Addendum No. 1

Project Name:	DDSB Dunbarton HS	Date:	January 23, 2026
Description:	Steam Decommissioning	From:	Brad Timson Sabastien Snow
Address:	655 Sheppard Avenue Pickering, ON	Project No:	A0001060
Client Contact:	Pat Cook, DDSB	DDSB Tender No:	T25-62

DUNBARTON HS STEAM DECOMMISSIONING PH 1 REVISED DEMOLITION LAYOUT

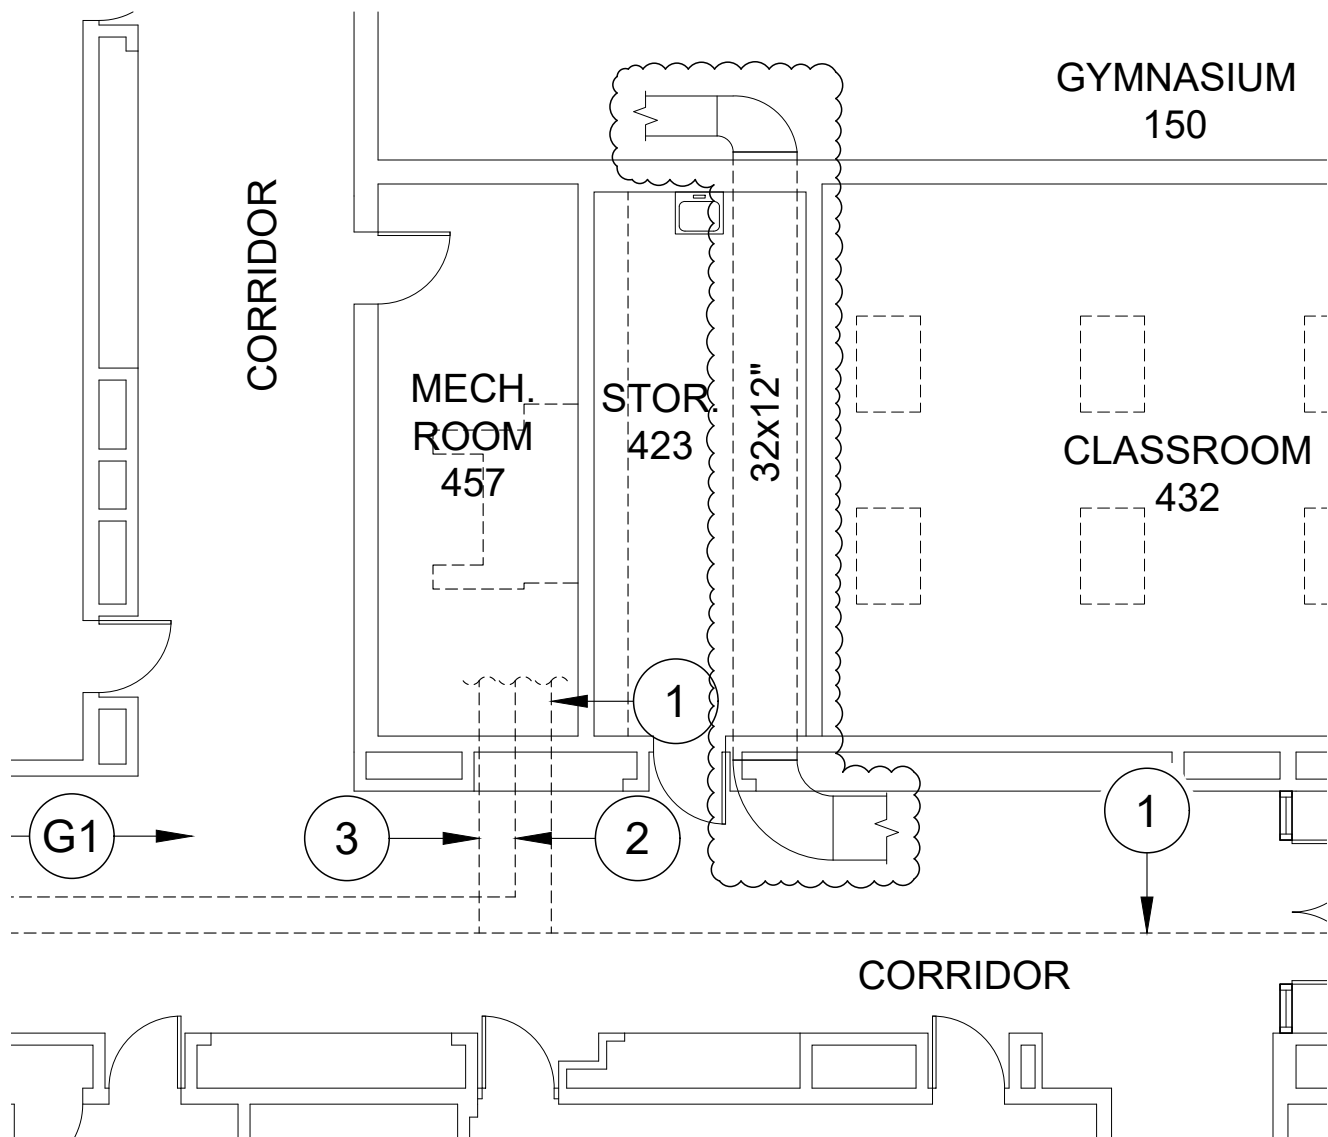
- .2 Disconnect and remove existing 32x12" S/A duct serving Stage Area. run through bottom of new bulkhead and reconnect to duct through wall to Stage. Refer to attached SK-M1 and SK-M2. Allow up to four (4) additional 32x12" square elbows with turning vanes if required to change elevation of new duct.
